s110_nrf51822 migration document

Introduction to the s110_nrf51822 migration document

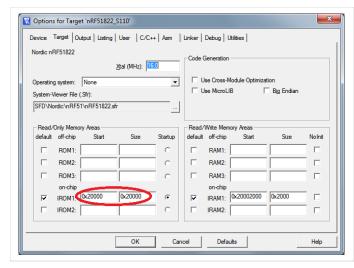
The flash requirements for the S110 SoftDevice have changed from 128kB to 80kB as of this version. All future releases of the S110 SoftDevice will require 80kB of flash memory (i.e. CODE_R1_BASE = 0x00014000). To adapt to this new size, applications will need to redefine their base addresses from 0x00020000 to 0x00014000.

In Keil, you can achieve this by changing the IROM1 value in the target options:

From:	То:
-------	-----
